CASE COVER SHEET

PLATINUM CONSTRUCTION
SITE PLAN
HORIZON RD. COMMERCIAL OFFICES
W.W FORD SURVEY, ABSTRACT NO. 80, TRACT 26-4
CITY OF ROCKWALL, ROCKWALL COUNTY, TEXAS

SITE PLAN
HORIZON ROAD
2.7391 ACRES BEING SITUATED IN THE W.W FORD SURVEY, ABSTRACT NO. 80
CITY OF ROCKWALL, ROCKWALL COUNTY, TEXAS
SUBMITTED: SEPTEMBER 13, 2024

SP2024-040: Site Plan for an Office Building at 5543 Horizon Road

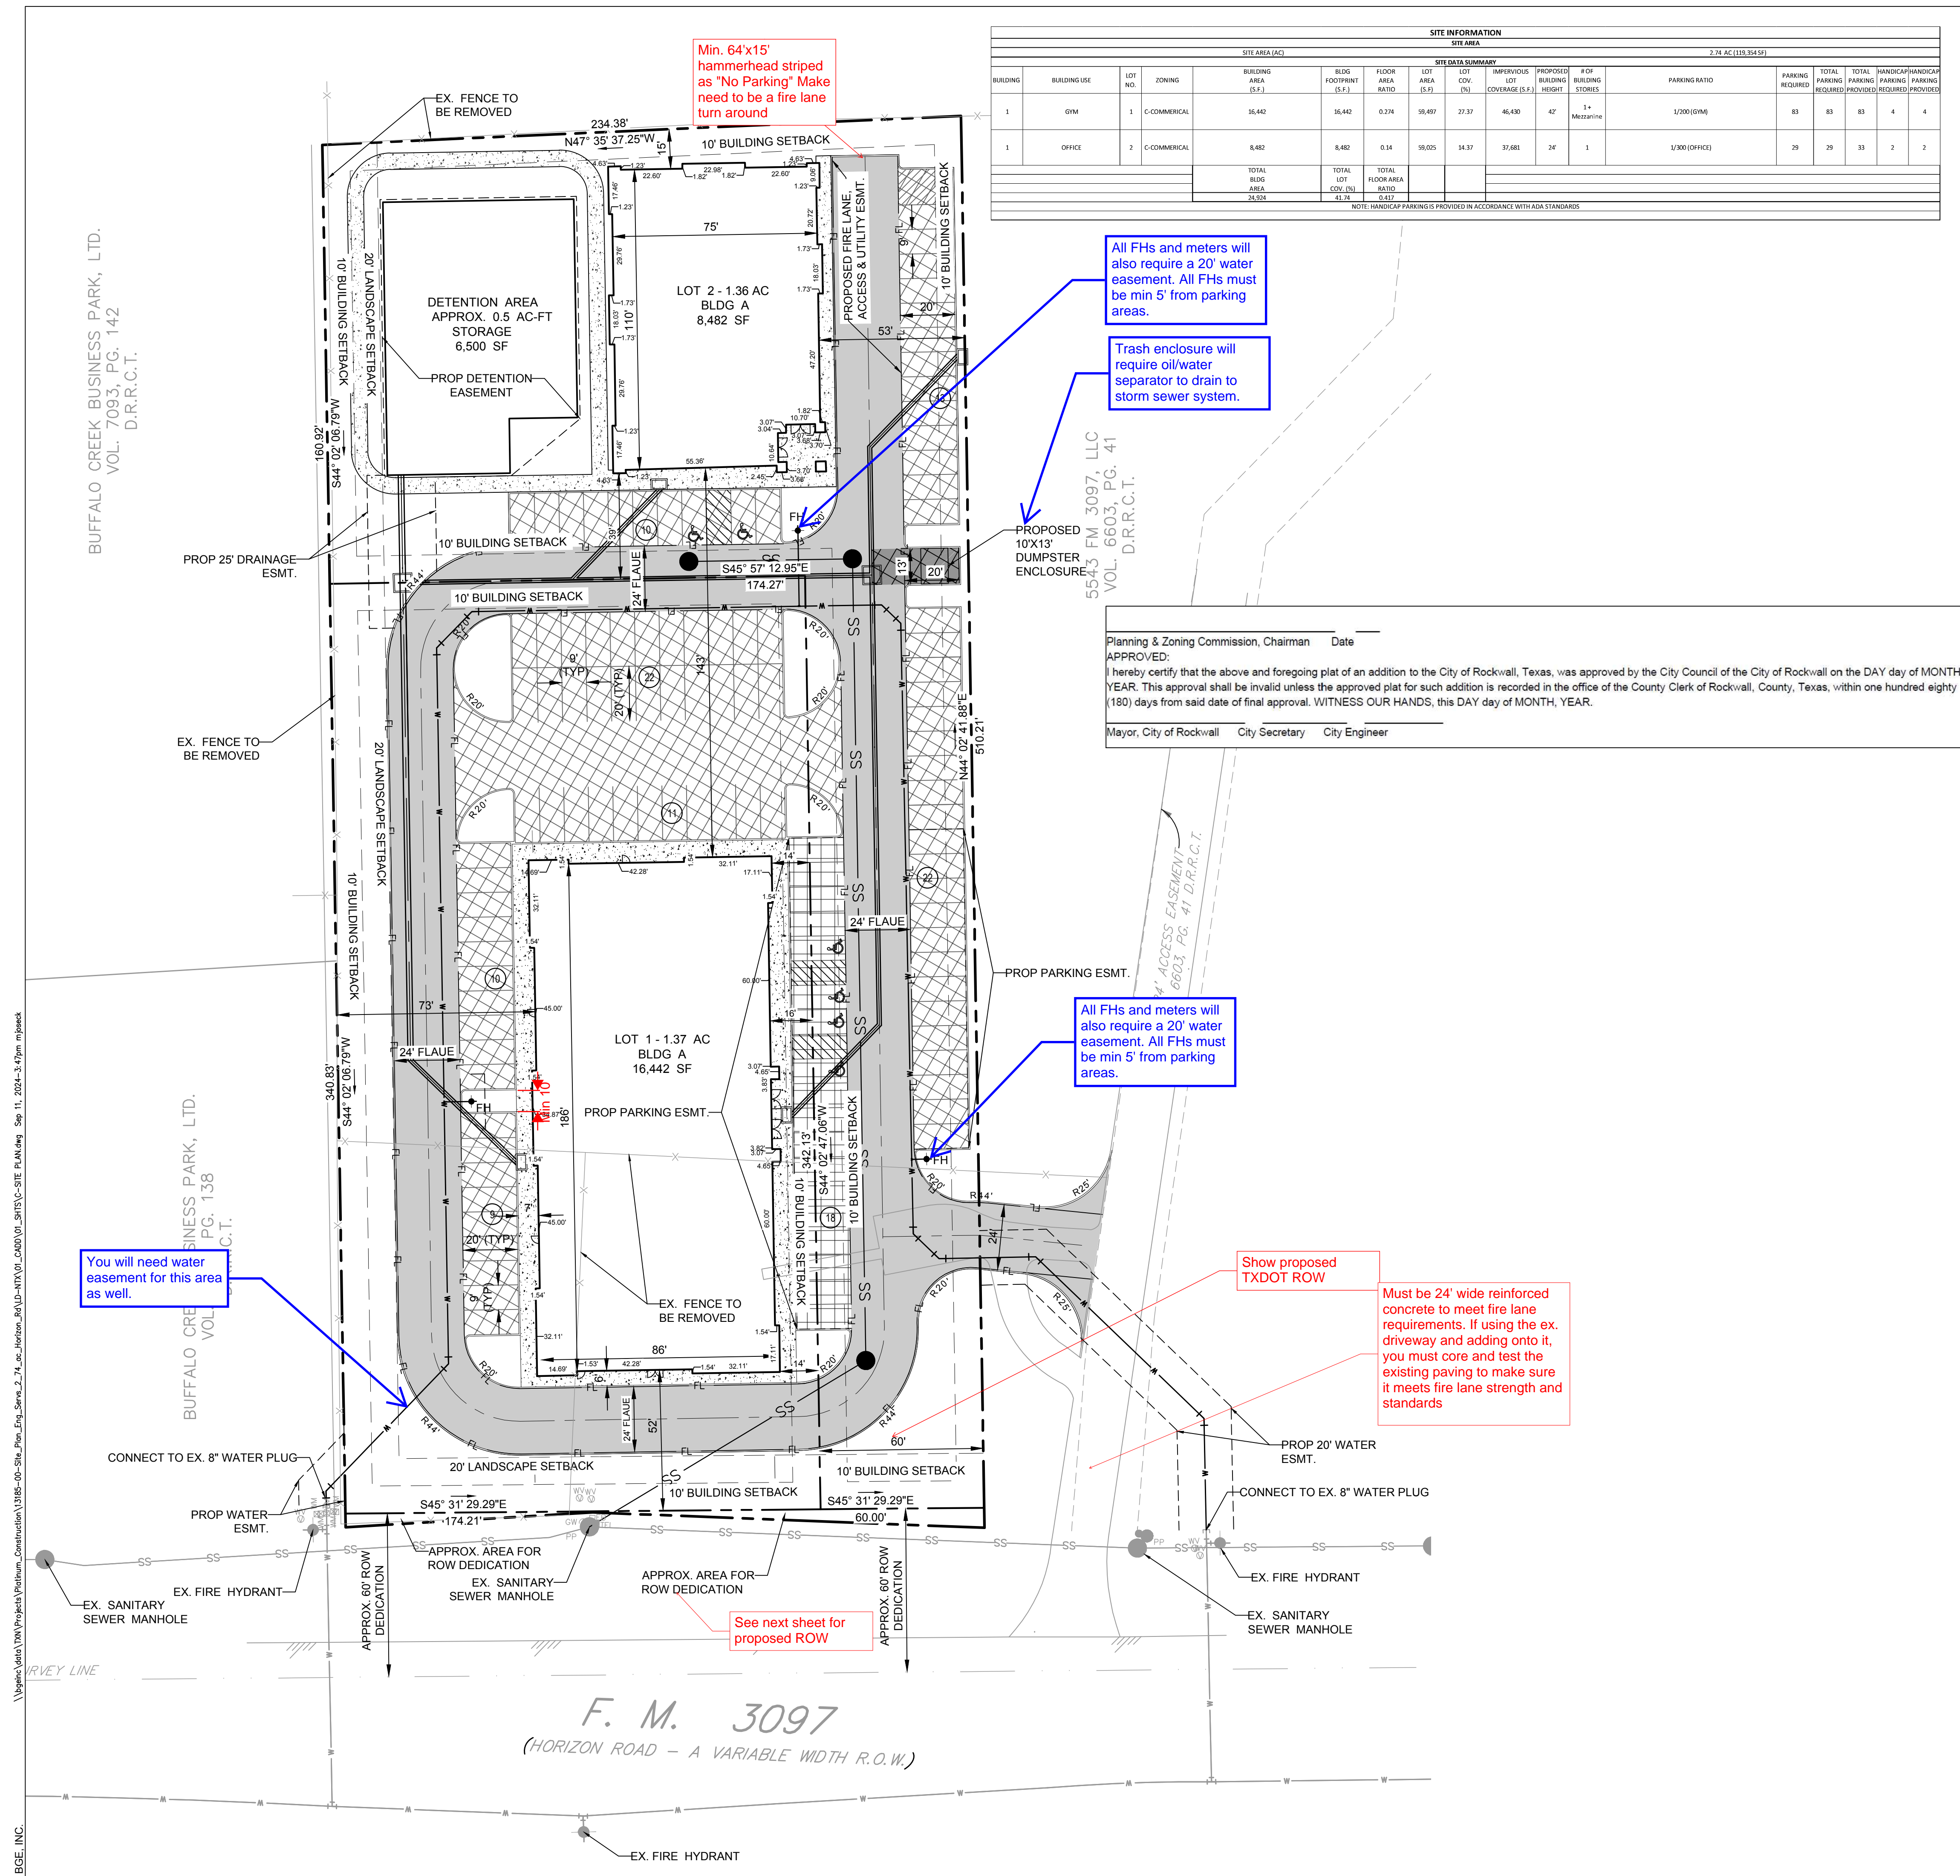
- 09/16/2024: 1. Please refer to the new legend required for reporting tree mitigation
2. You may have difficult time finding Caddo Maples
3. Recommendation only as there are many turfgrass varieties available that are more drought, cold, shade and wear tolerant such as Tif Tuf, Tahoma 31, Latitude 36.
4. Make sure all parking spaces are within 80' of tree canopy
5. Please provide seed specifications for the (2) mixes
6. Make sure that all trees are planted 5 and 10 feet from utilities based on line size.
